**REVISION
TO
VOLUME IV OF IV REPLACEMENT
AMENDMENT TO FINAL CLOSURE PLAN
LOPEZ CANYON SANITARY LANDFILL
LAKEVIEW TERRACE, CALIFORNIA**

**BOARD'S COMMENTS ON REPLACEMENT VOLUME IV OF THE FINAL
CLOSURE PLAN FOR LOPEZ CANYON SANITARY LANDFILL**

SUMMARY TABLE OF REVISIONS TO VOLUME IV OF IV REPLACEMENT AMENDMENT TO FINAL CLOSURE PLAN

Subject: Adequacy of the Replacement Volume IV of the Final Closure Plan
for Lopez Canyon Sanitary Landfill, City of Los Angeles, Facility
No. 19-AA-0820

FIGURE NO. 2-1 (b)

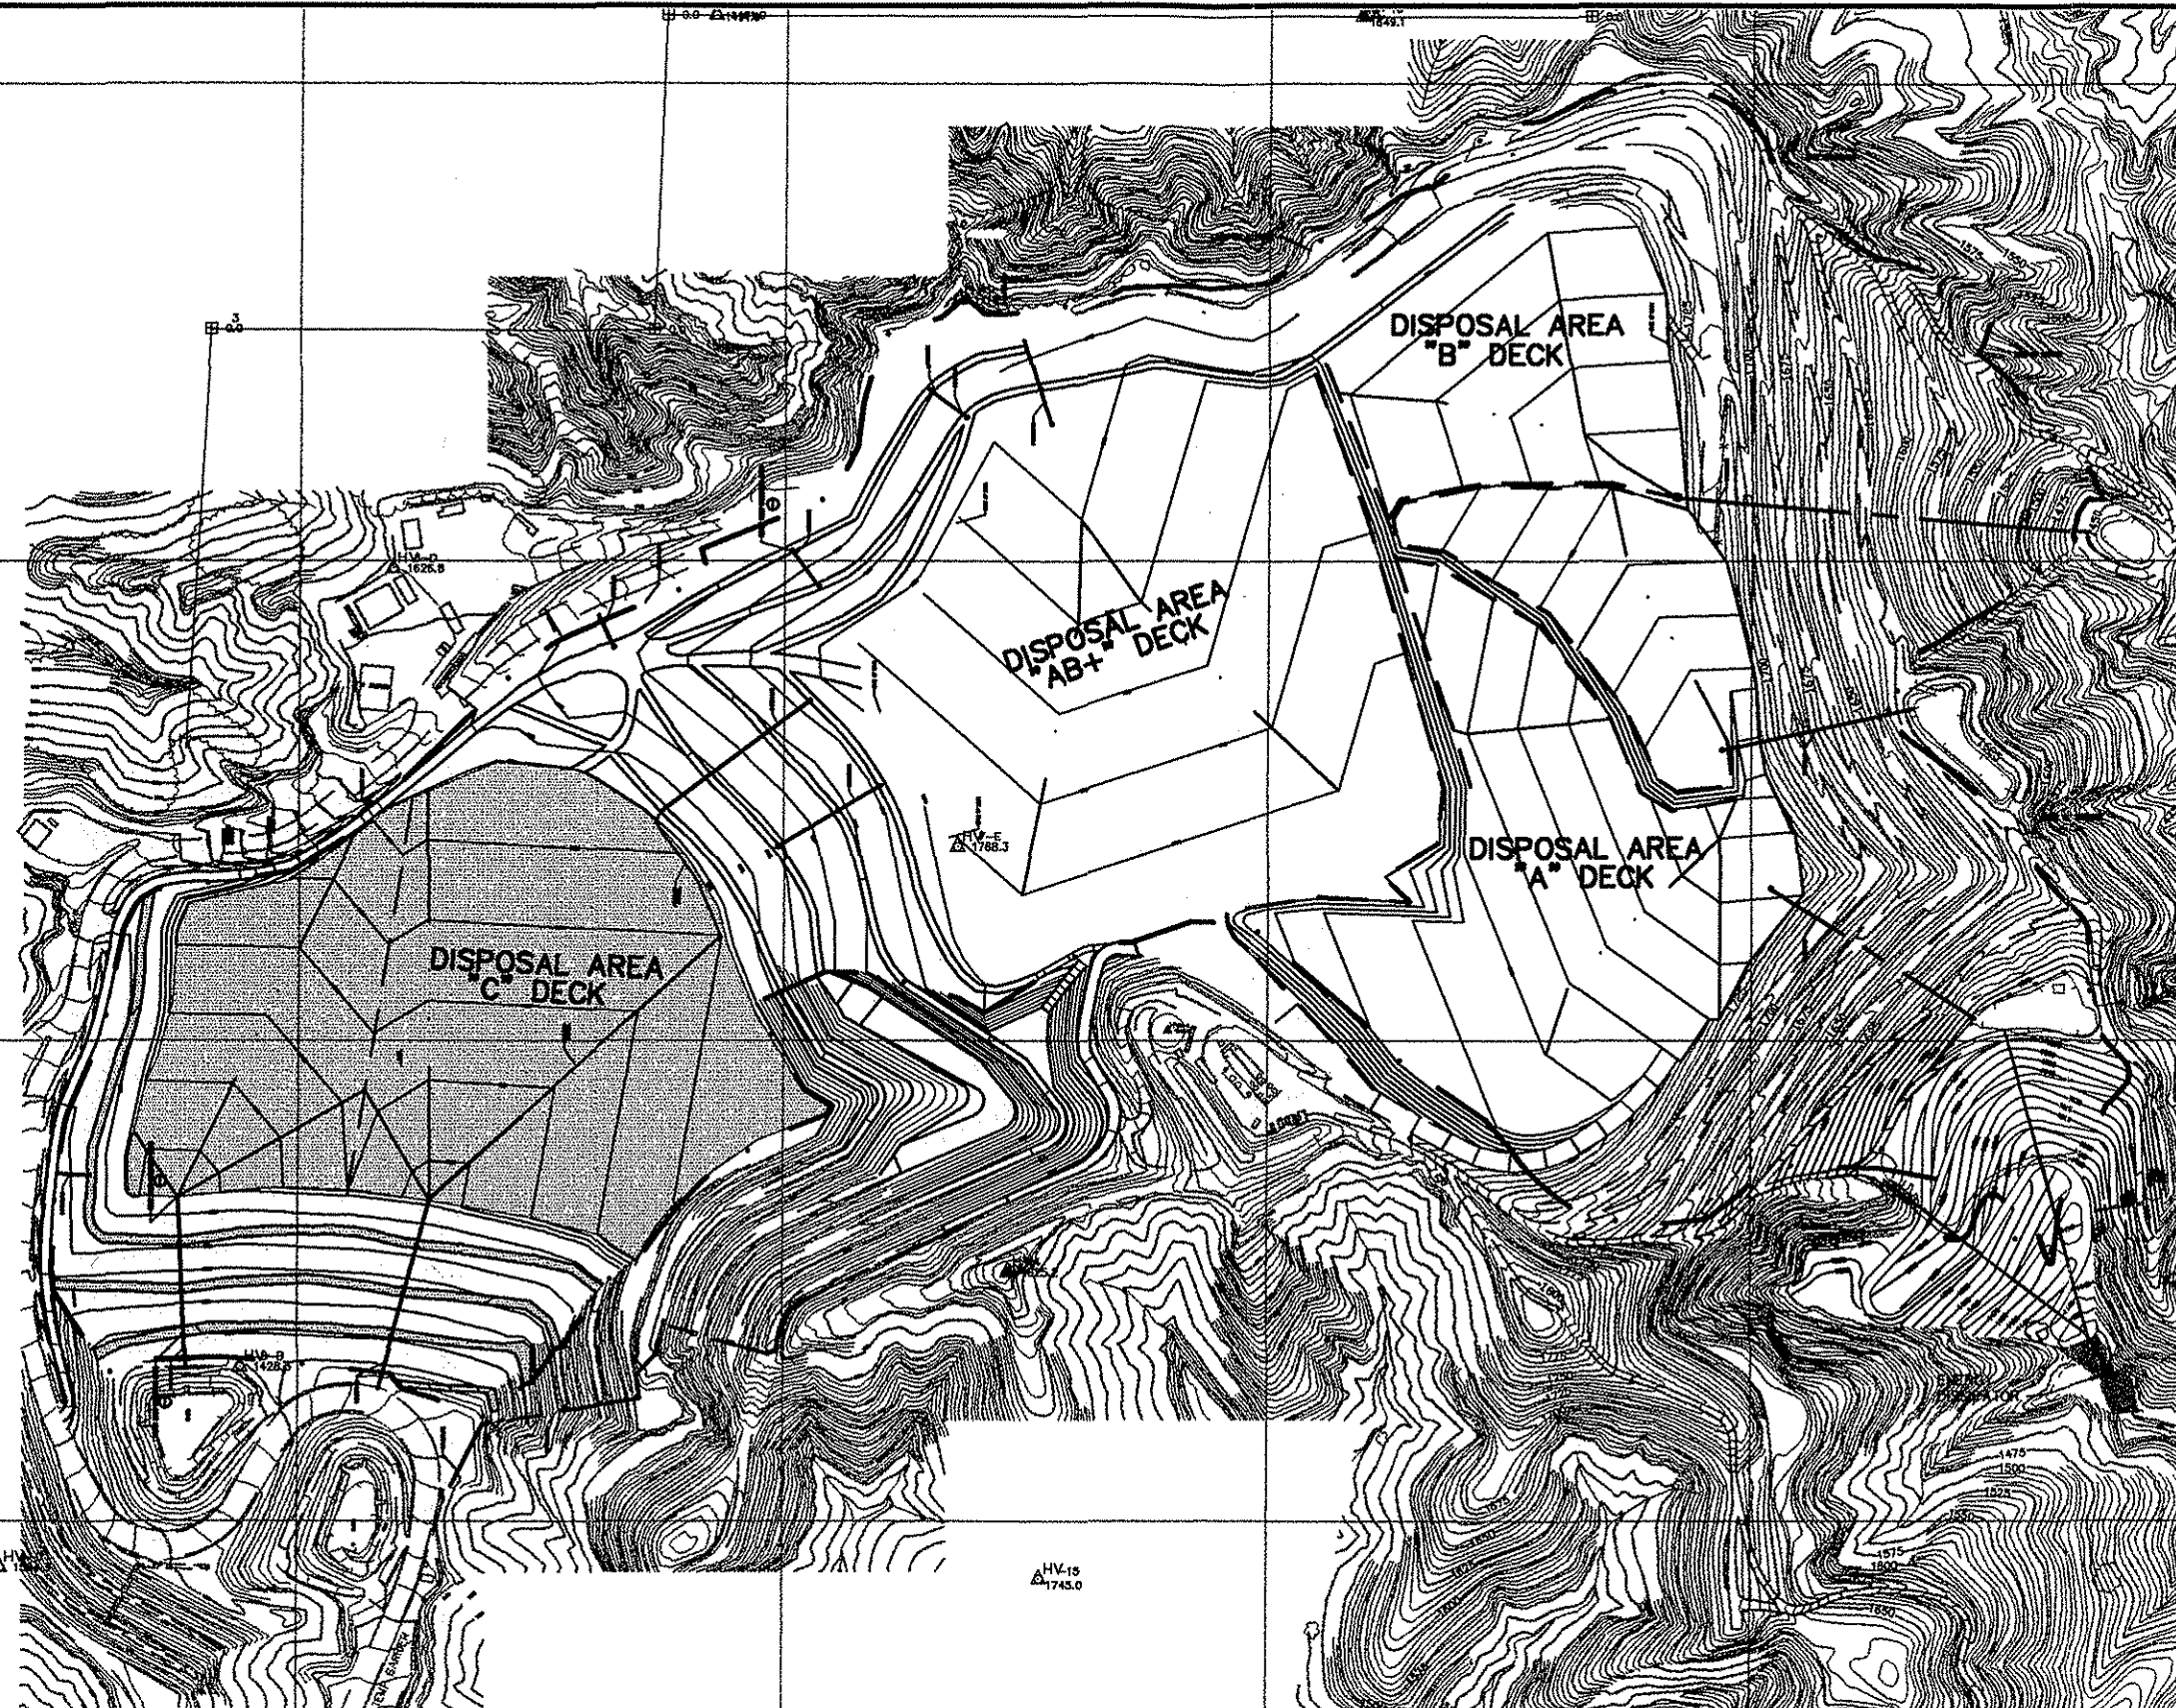
"The revised plan indicates that the top deck and benches of Area "C" will incorporate a 40-mil very flexible polyethylene (VFPE) synthetic membrane (smooth on the top deck and textured on the benches). However, Section 2.3, Revised Final Cover Configuration, does not include detailed design information or any design justification which is expected from a final closure plan. Specifically:

- b. The plan must include calculations supporting use of VFPE (shear stress, VFPE elongation vs. differential settlement, anchorage, etc.).*
- c. The plan must include design drawings showing synthetic membrane system key points (anchors [if present], key points, pipe intercepts, etc.).*

- (b) GeoSyntec has provided an analysis of the VFPE geomembrane to be used on the deck and benches of Area C. See Attachment F. This is to be included under Appendix III of Appendix H of the final closure plan. Section 3.2 of Appendix H has been revised to reflect this reference.
- (c) Drawings showing the extent of the synthetic membrane and corresponding key points in Area C are included in the Figures Section, Figure 2-1(a) through 2-1(e).
- (d) Appendix I, "Revised Construction Quality Assurance Plan," of the closure plan has been revised to include an appendix that provides supporting documentation used to establish the minimum design yield point. See attachment G.
- (e) Design drawings for the haul road which is to be reconstructed over refuse to the north of area AB+ have been included in the Figures Section, Figures 2-4 and 2-4(a) of the closure plan. See attachment E.

FIGURE NO. 2-2(b)

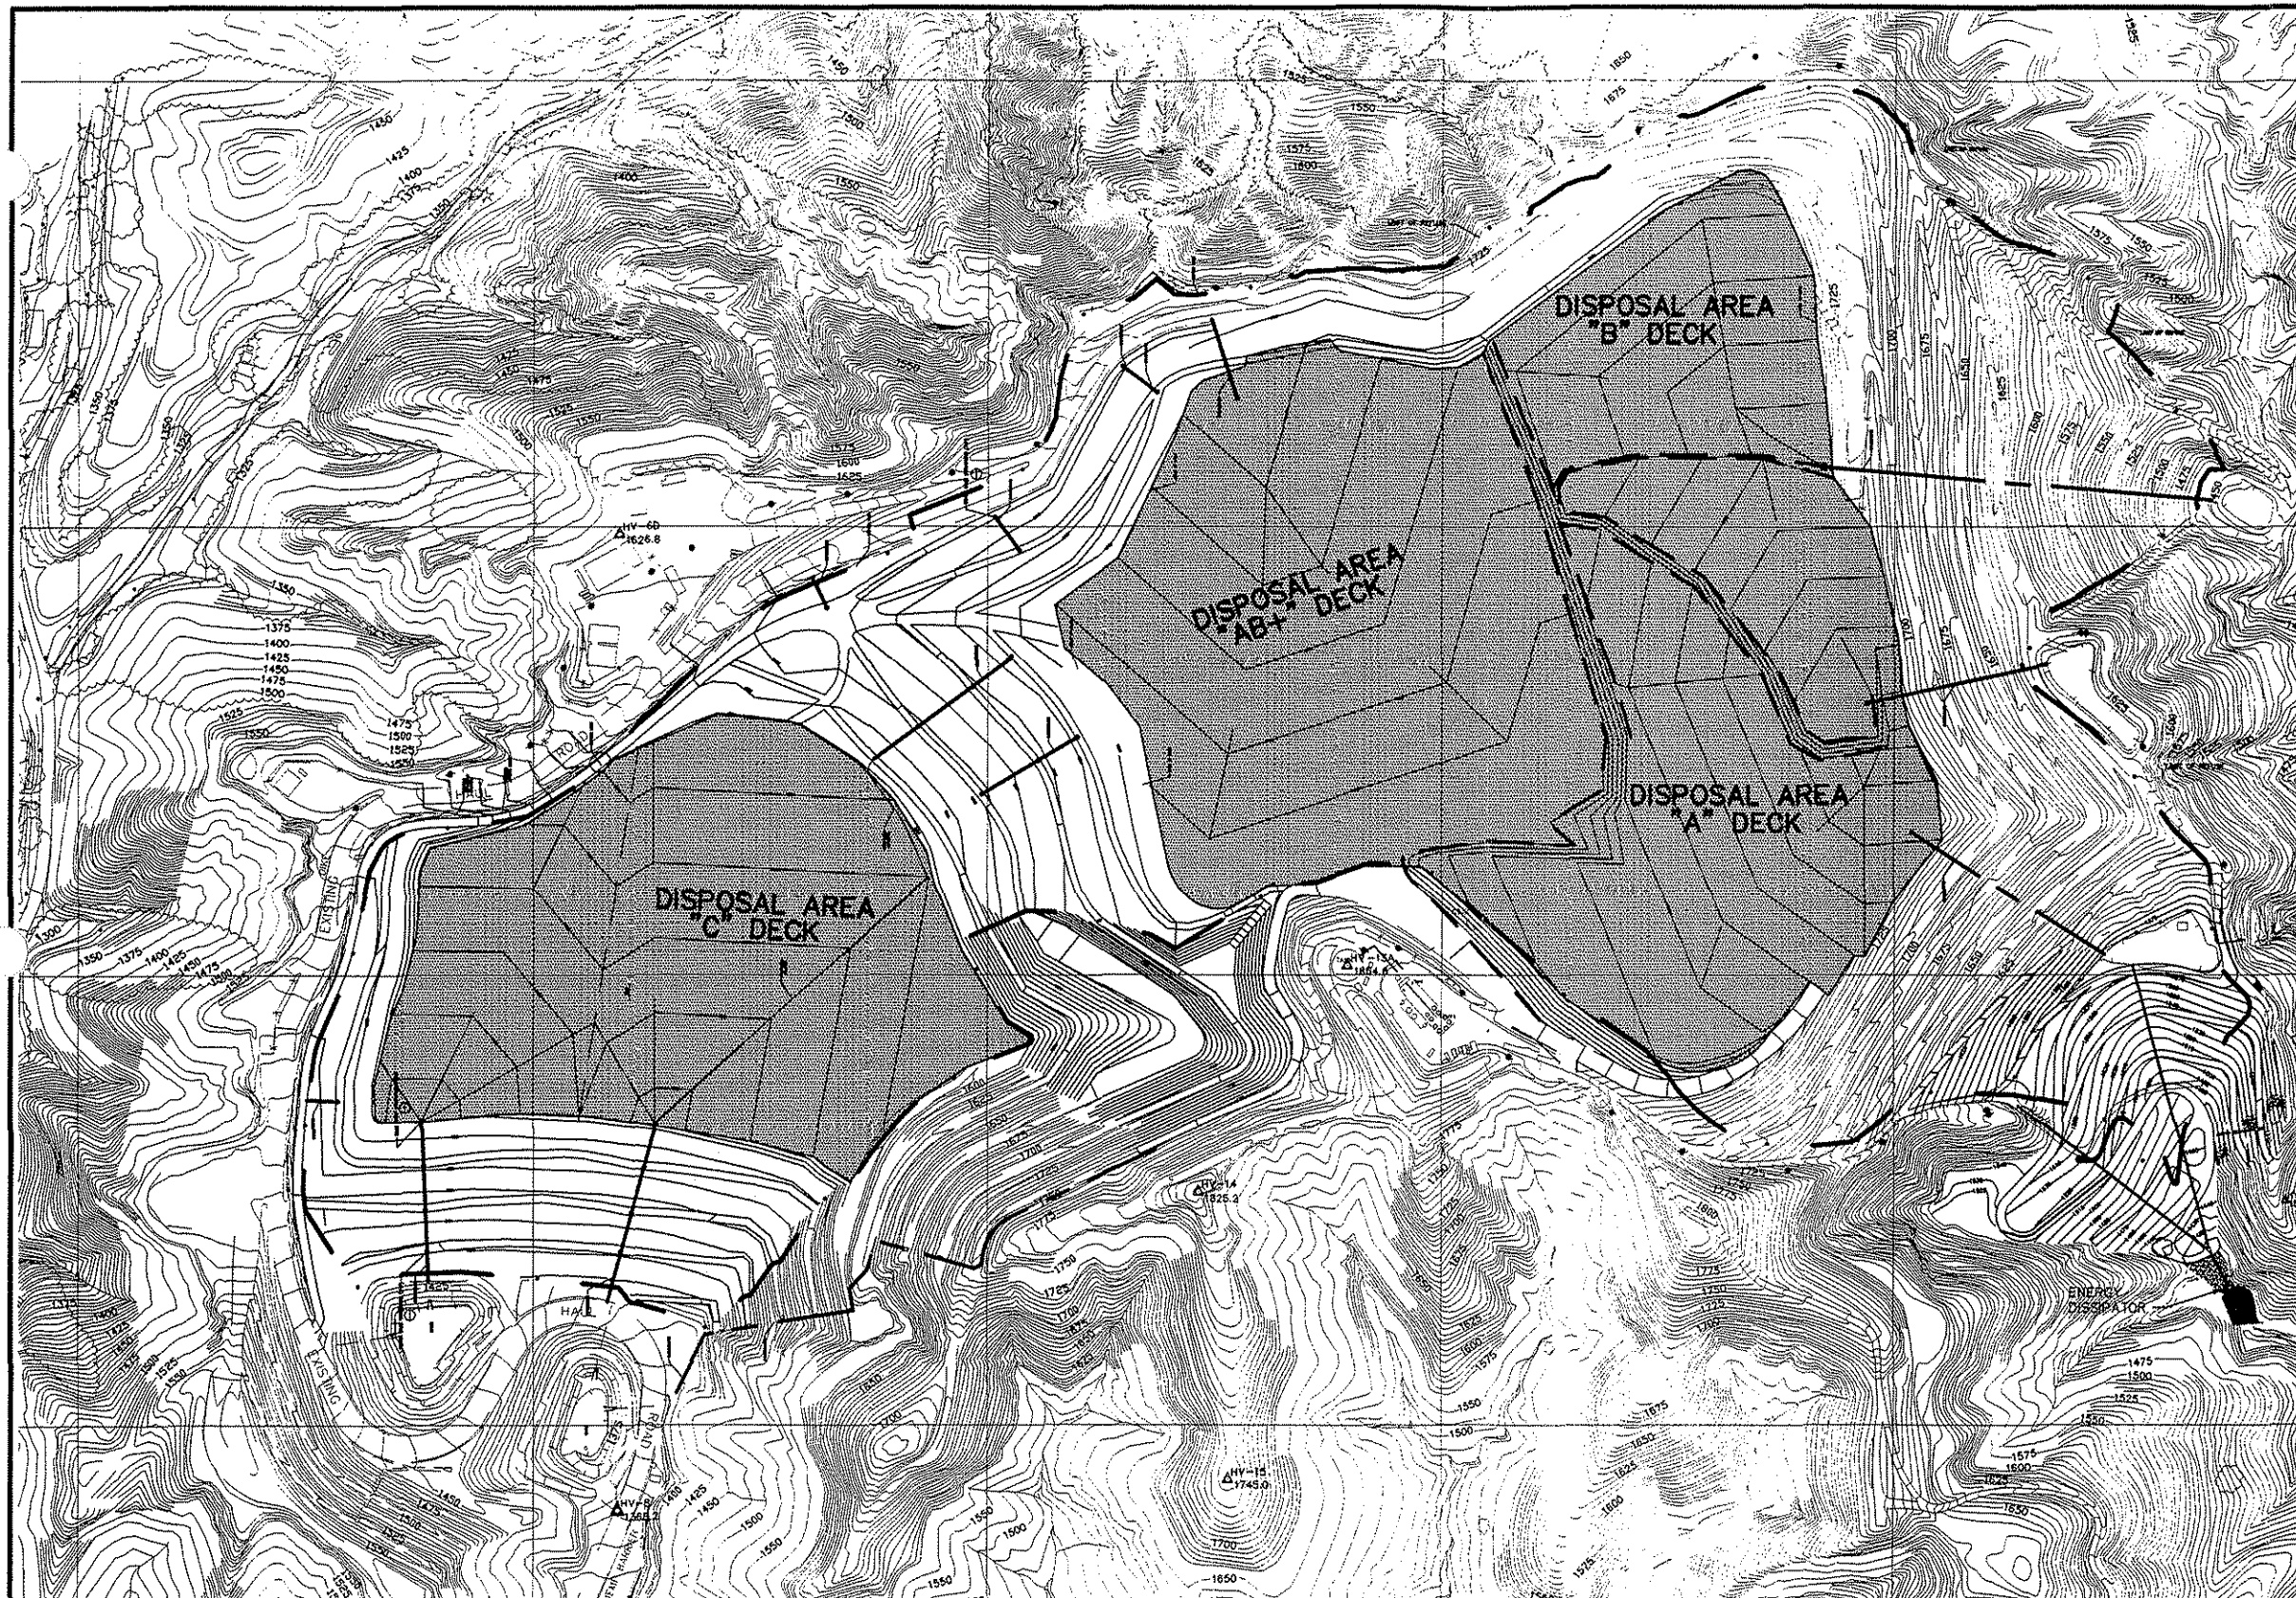
Also, the same section of text states that a geosynthetic clay liner (GCL) may be used as a barrier layer in the event a low permeability source is not available. Since the current submittal is identified as the final closure plan, the issue of securing sufficient volumes of cover material should be already resolved. Since the current cost estimate accounts for a clay low permeability material at a specific cost, this statement raises concern about the accuracy of the cost estimate.

The Bureau would like to reserve the option of using a geosynthetic clay liner (GCL) on the decks of Areas A, B AB+ and C. Final cover drawings using this option are shown in Figures 2-1(a) and 2-2(a), and technical specifications for GCL are shown in Table 2-2. Sections 2.3.1 and 2.3.2 of the closure plan have been modified to include the above revisions, (see attachment E). The Bureau will notify the Board, LEA and RWQCB, and update the grading plan, and postclosure maintenance plan, if this option is chosen. The QA/QC plan has been revised to include the GCL option, (see attachment G).

FIGURE NO. 2-2

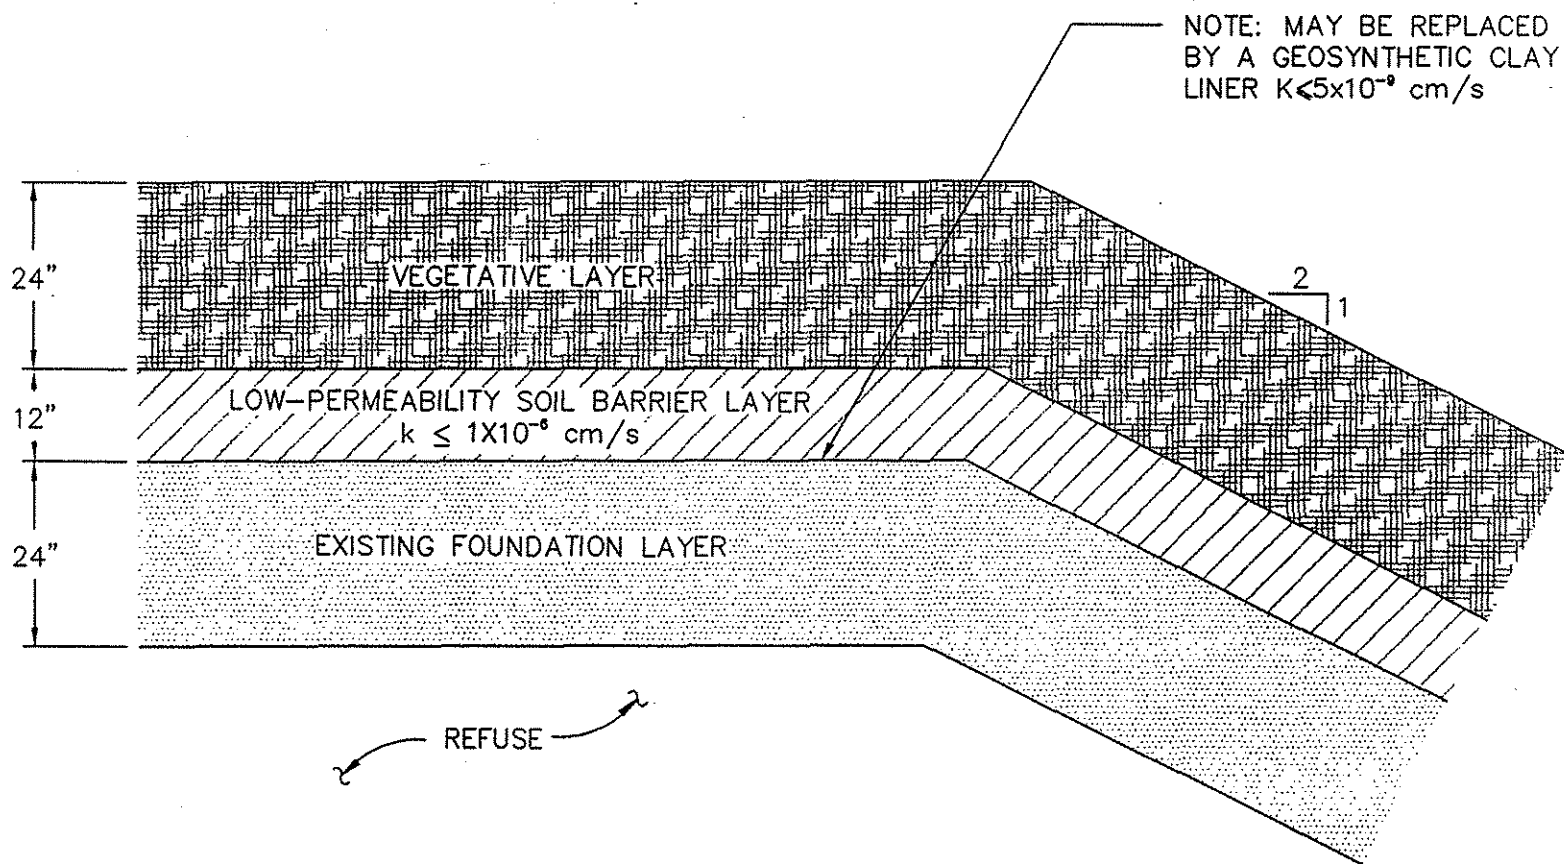
Section 2.3.2, Revised Final Cover Configuration, Disposal Area A, B, and AB+ Deck Areas, states that the geotextile between the vegetative layer and low permeability layer had been deleted. Please provide an explanation why this change occurred.

The final cover on the deck of Disposal Areas A, B, and AB+ has been modified from that presented in the PCP to delete the geotextile between the vegetative layer and the low-permeability soil barrier layer. In addition, a geosynthetic clay liner (GCL) with a hydraulic conductivity no greater than 5×10^{-9} cm/s may be used as a barrier layer. The use of a GCL will depend on the availability of low-permeability soil, ease of application, and economical feasibility. The modified final cover is presented in Figures 2-2 through 2-2(d).
